Subject: **Request for Modification of Section 404 General Permit No. 198200031 and Section 401 Water Quality Certification, and lifting of Notice of Violation Status** for the Interstate 85 (I-85) widening and interchange improvements from north of NC 73 to north of SR 1280, Cabarrus and Rowan Counties, Divisions 9 and 10. Federal Aid Project No. NHIMF-085-2(61)55, TIP I-3802A.

The North Carolina Department of Transportation (NCDOT) requests modification to the existing General Permit No. 198200031 and associated Water Quality Certification for widening and interchange improvements along I-85 in Cabarrus and Rowan Counties. This project is currently under construction.

Revisions have been made to seventeen impact sites and are discussed in detail below. Two new impact sites are also discussed below (Site 36 and the Troutman waste site).

PROJECT REFERENCE NO. I-3802A	SHEET NO. 36
RW SHEET NO.	
ROADWAY DESIGN ENGINEER	HYDRAULICS ENGINEER
BLYTHE

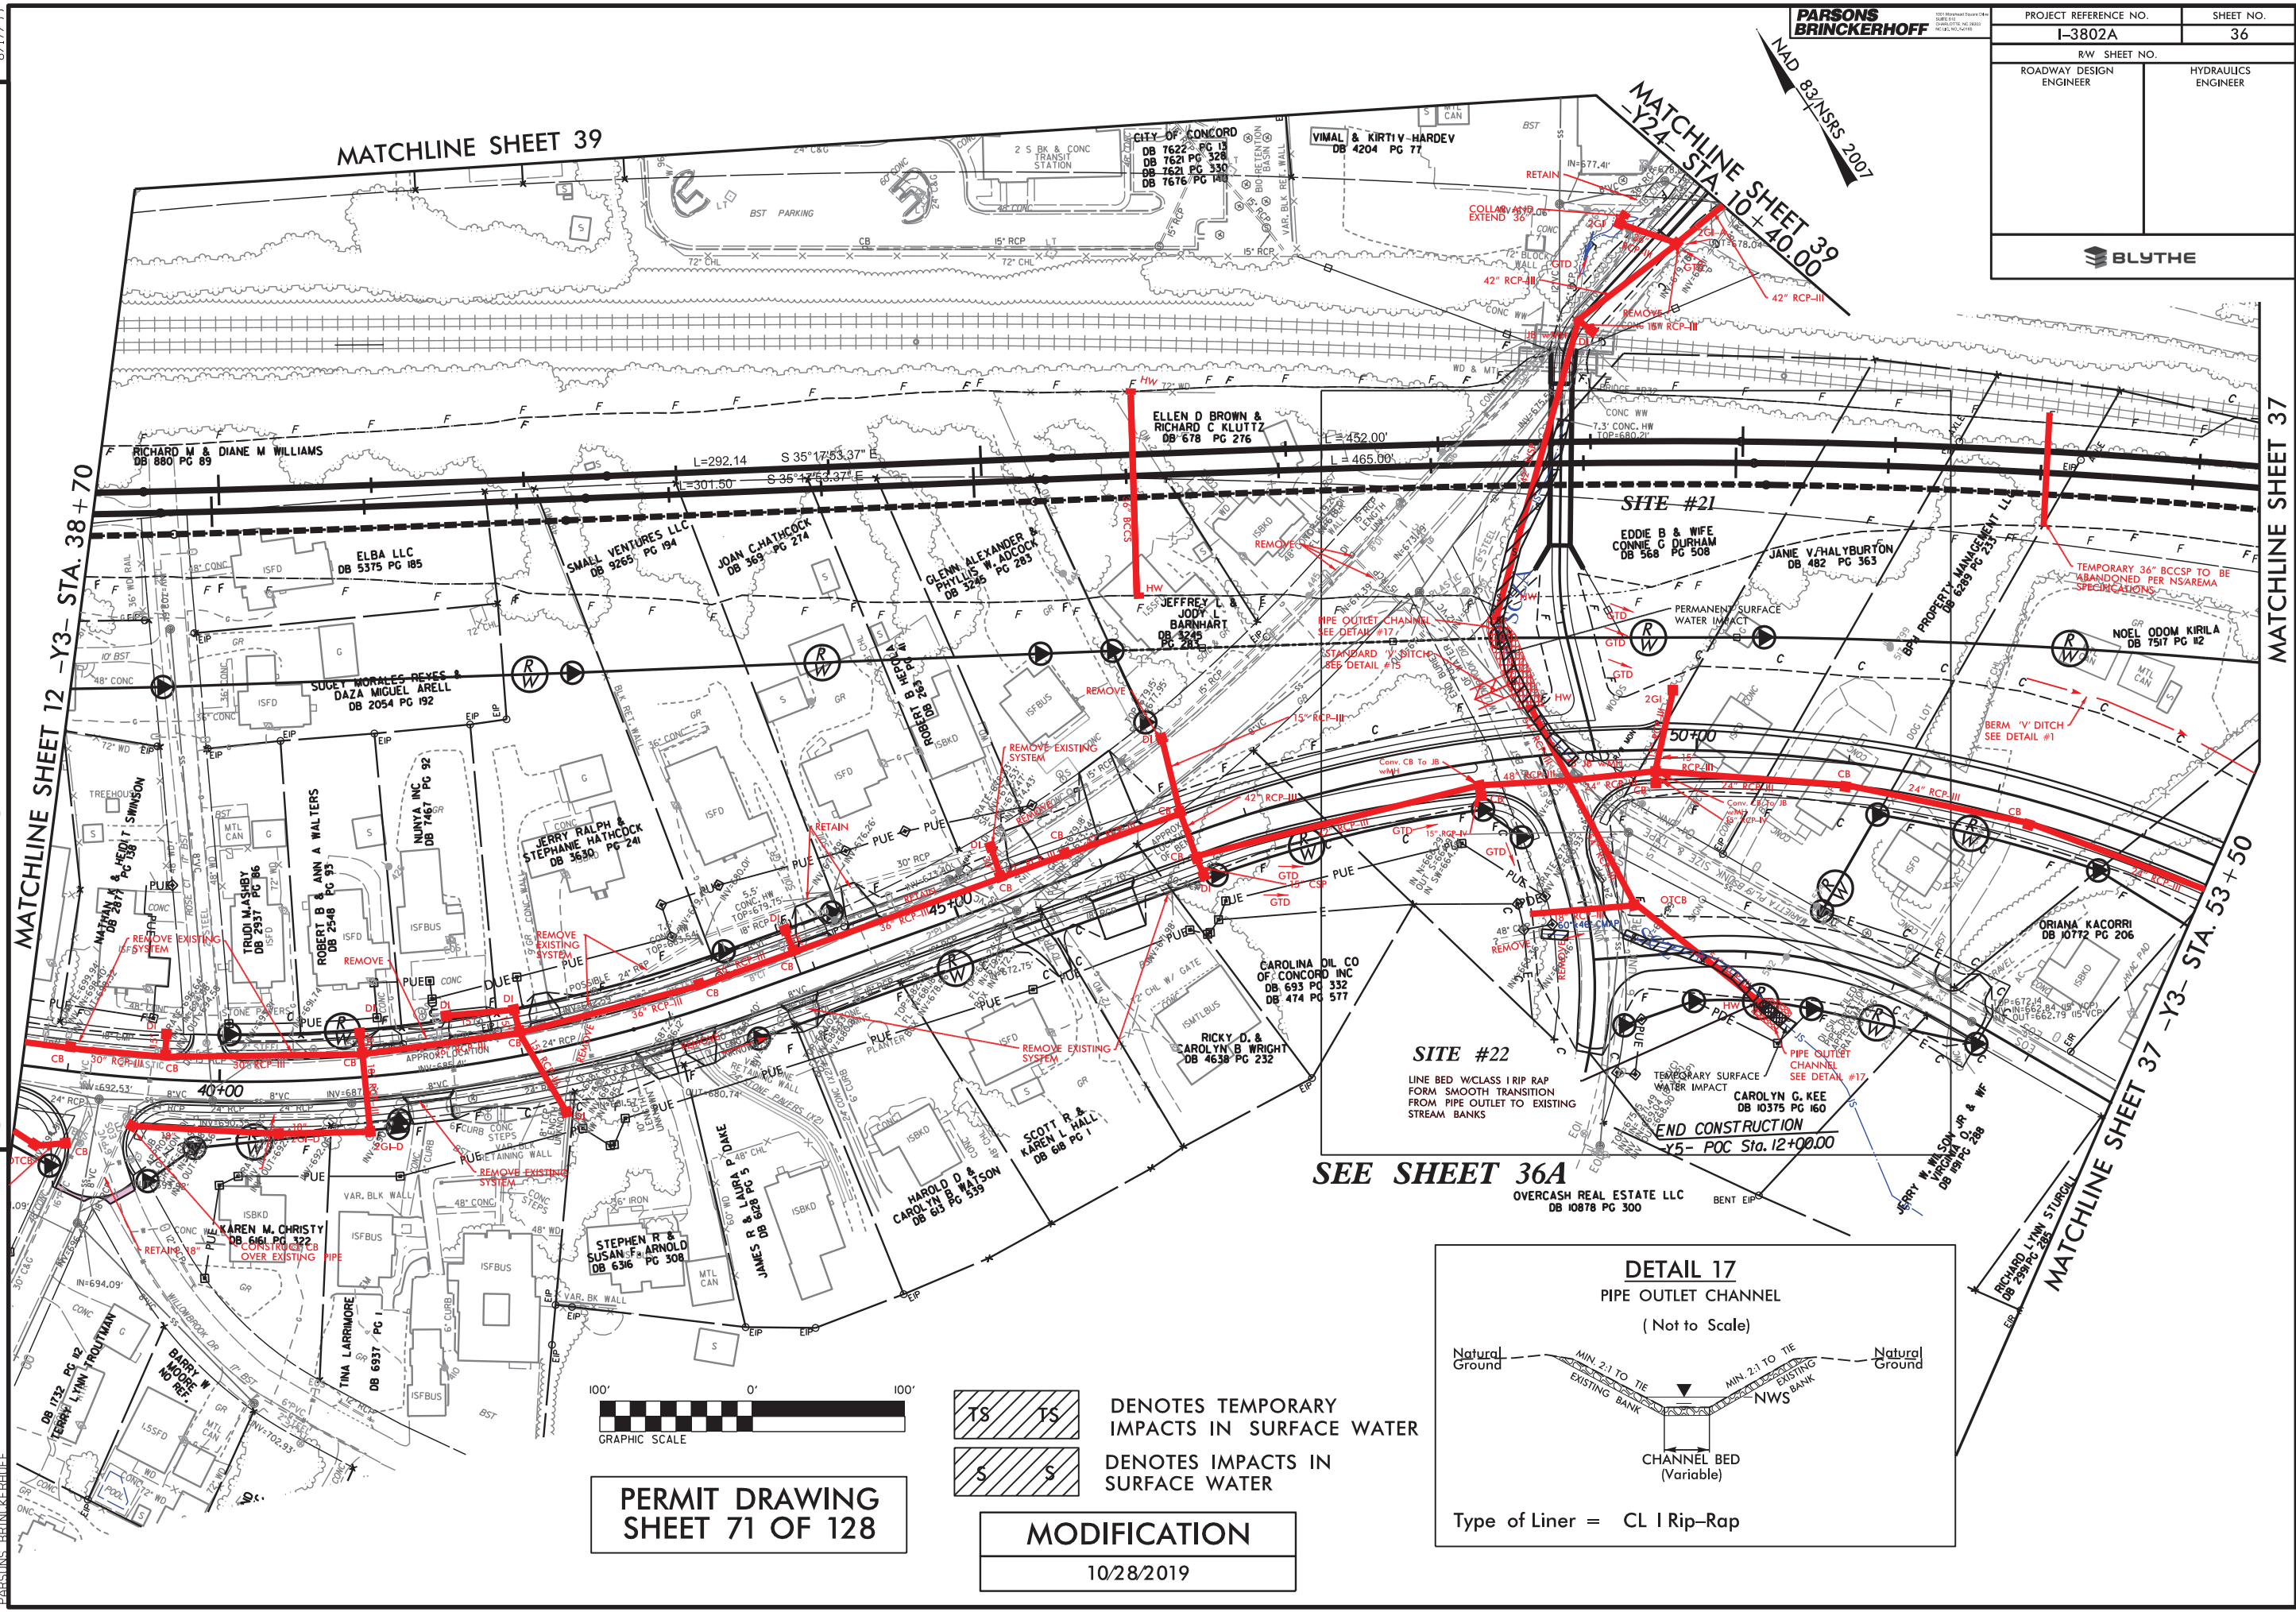
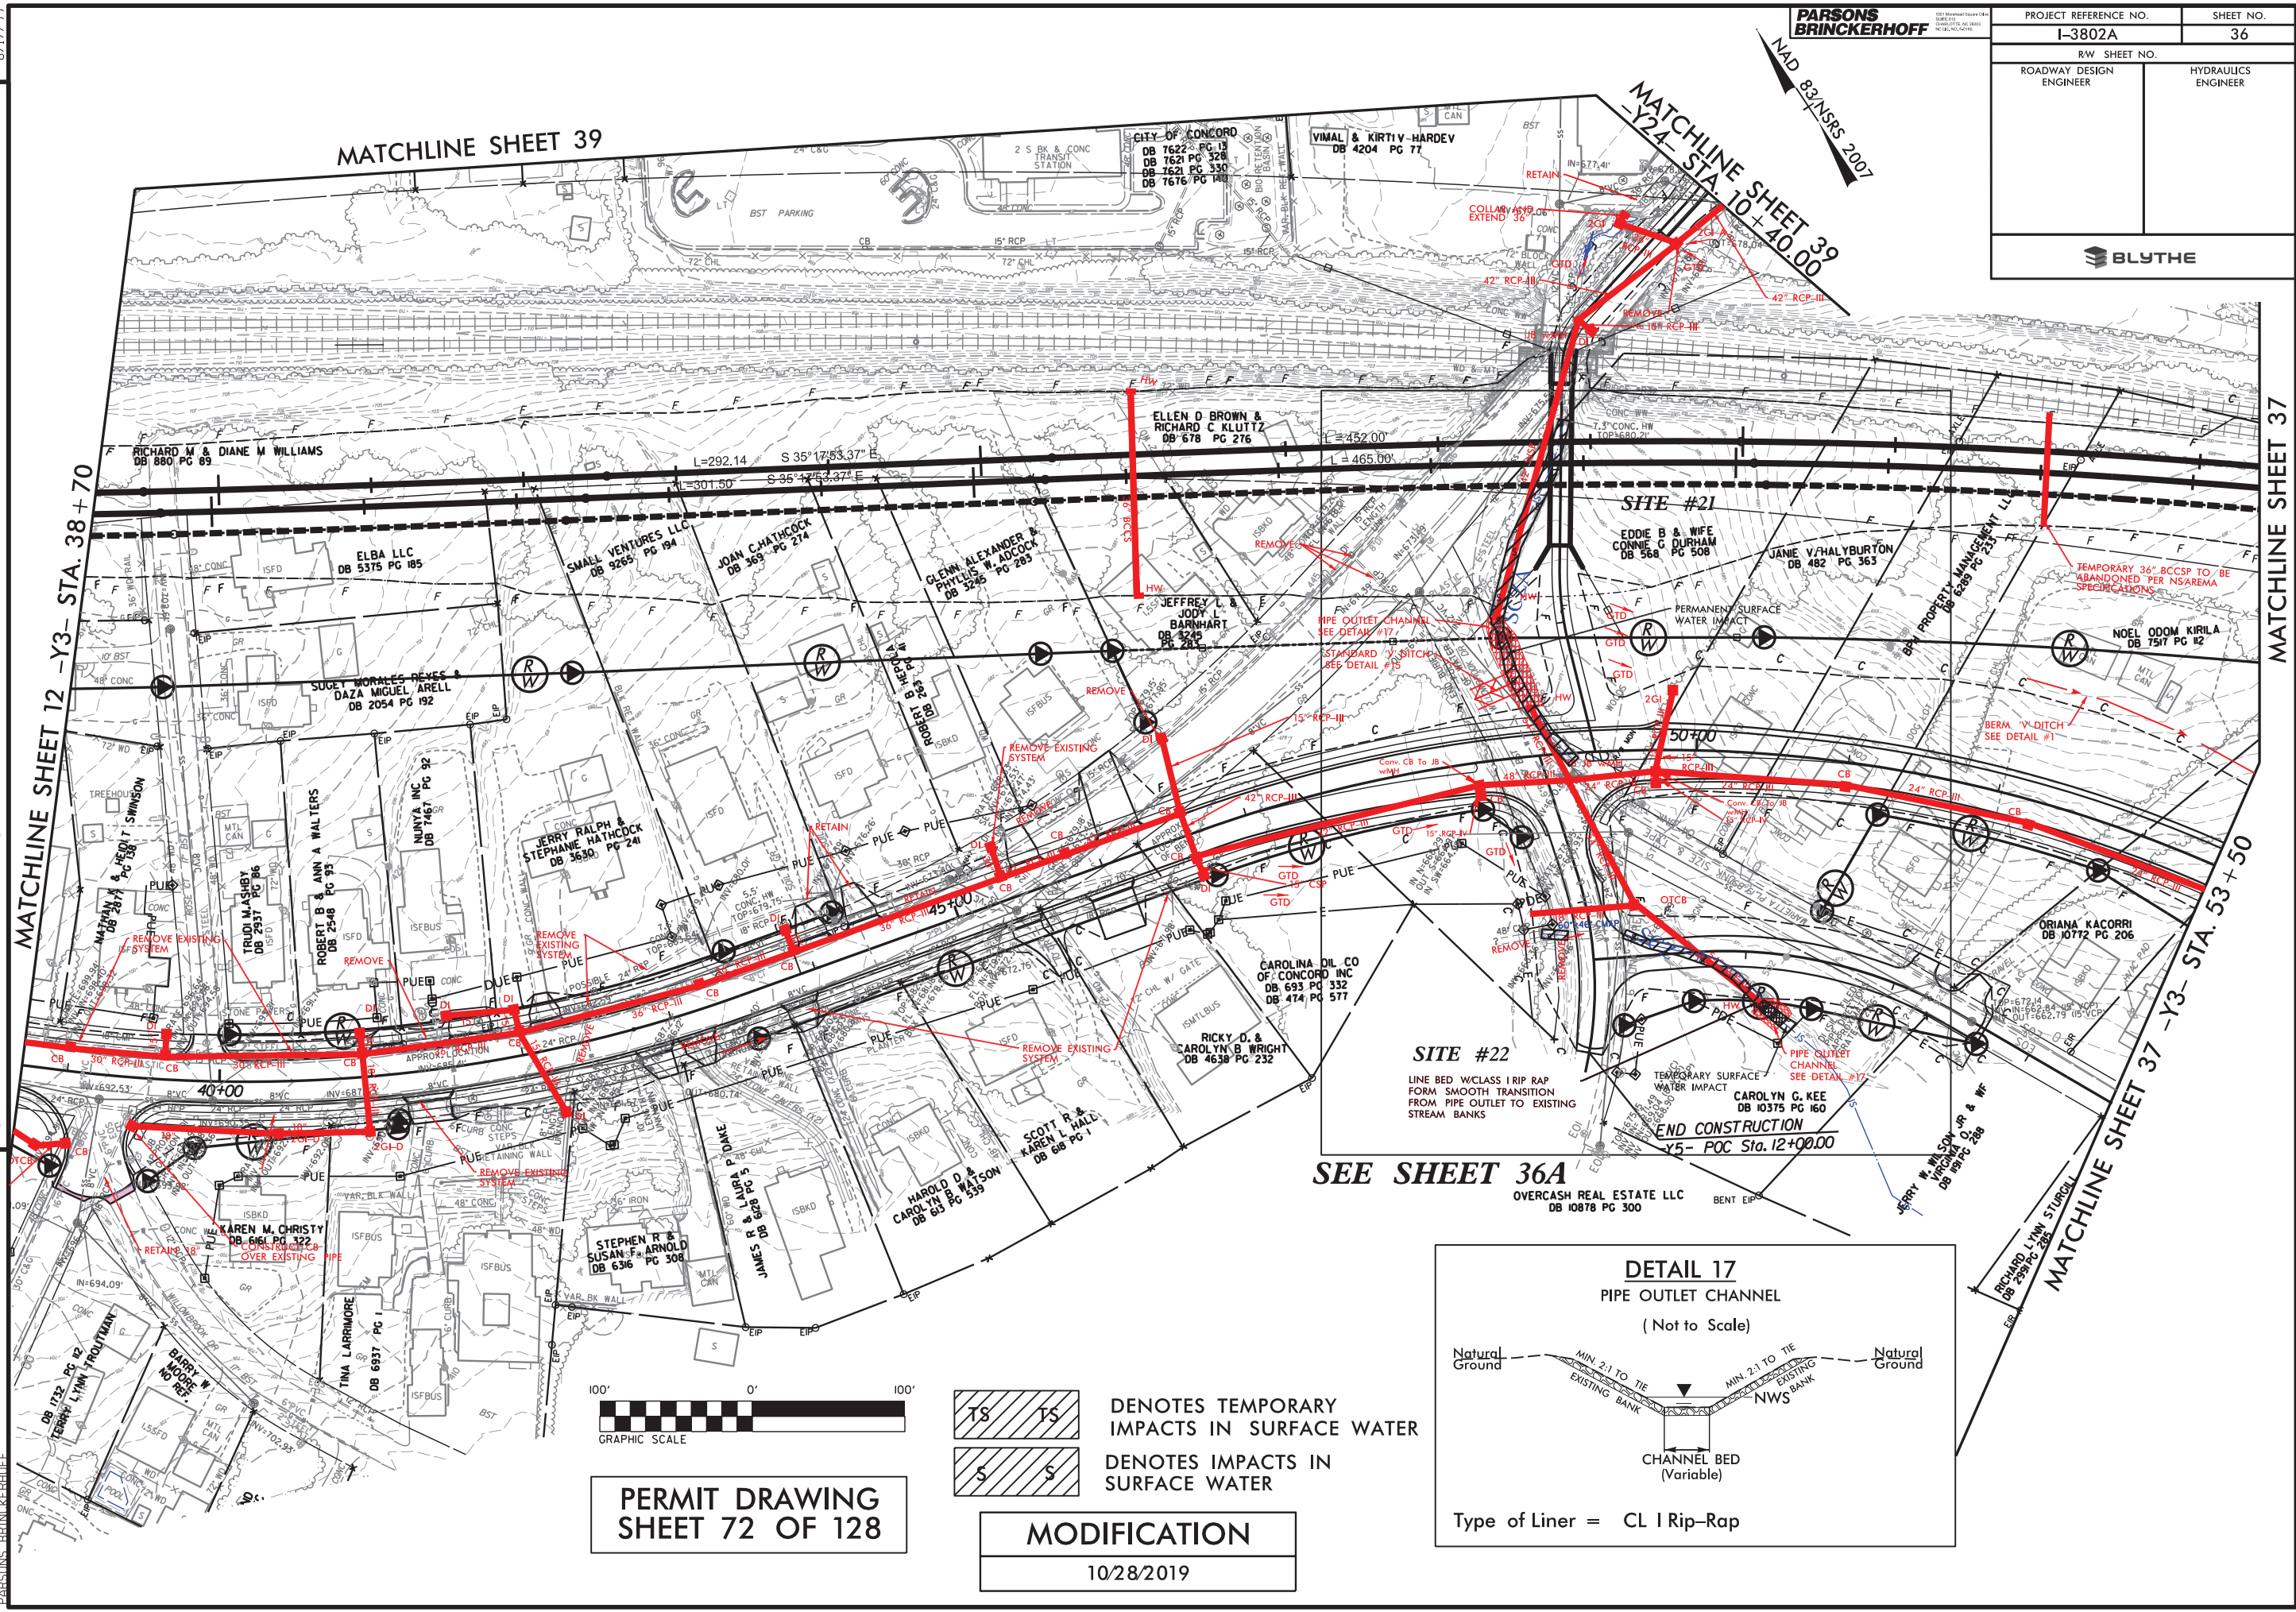
Site 21 (Sheet 36) – The original drainage design attempted to minimize impacts by limiting bank stabilization for stream SCZA to 15 linear feet at the pipe outlet. During construction, the contractor inadvertently cleared an additional 67 linear feet of stream bank, which then required additional bank stabilization. Class I rip rap was later installed in the stream bed for the entire length of the channel to address erosion issues. Permanent stream impacts increased from 210 linear feet to 277 linear feet, which is 67 linear feet of additional impacts. The 15 linear feet of stream bank stabilization impacts from the original design are accounted for in the additional 67 linear feet of permanent stream impacts, therefore stream bank stabilization impacts are reduced to 0 linear feet at this site. Temporary stream impacts were reduced from 20 linear feet to 0 linear feet.
